UNITED STATES PATENT AND TRADEMARK OFFICE

APPLICATION NO.	FILING DATE	FIRST NAMED INVENTOR	ATTORNEY DOCKET NO.	CONFIRMATION NO.
09/321,633	05/28/1999	JAMES W. KENNEY	E-1901	6762

Office Action Summary

DETAILED ACTION

FIG. 20

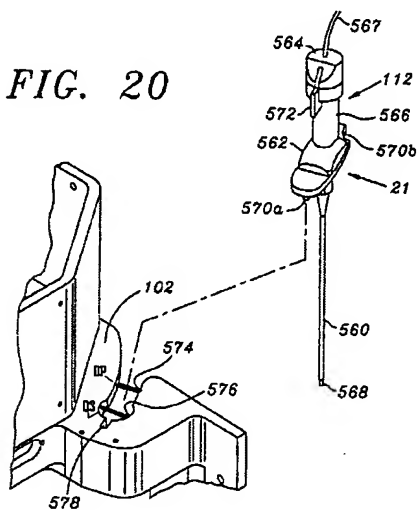
Additionally, this switch, through the microprocessor 43, automatically activates/deactivates the air pressure source. Kenney fails to teach a gun holster arranged to support the gun above the worktable. Goodale *et al* teach a pipette holster used to support the pipette 112 above a worktable in a vertical direction. Goodale *et al* teach a mounting bracket 102 having a fork with prongs 574 and a circular socket 576 constructed to removably hold the pipette. Wherein the socket is formed between the prong and has a diameter (DS) which is larger than the distance between the prongs (DP), (column 11, line 61- column 12, line 28, and modified Fig. 20 below.) The opening 576 is smaller in diameter than the head 564 such that the pipette probe 112 may be supported by the head 564 within the opening 576, the key 572 and keyway 578 cooperating to align the pipette probe 112 within the opening 576 and thus with respect to the frame 102. Such use of a bracket insures that the pipette tube does not touch anything and will remain sterile. Given this teaching, it would be obvious to one of ordinary skill that the pipette connector 564 and barrel 566 is inserted from the top such that it engages the socket 576.

Accordingly, it would have been obvious to one of ordinary skill in the art at the time of the invention to have included in the dispensing means of Kenney, the pipette holster, as taught by Goodale *et al* in order to insure that the pipette tube does not touch anything and will remain sterile while remaining securely restrained within the mounting bracket (column 2, lines 35-57 of Bale *et al* (USP 5,704,495)).
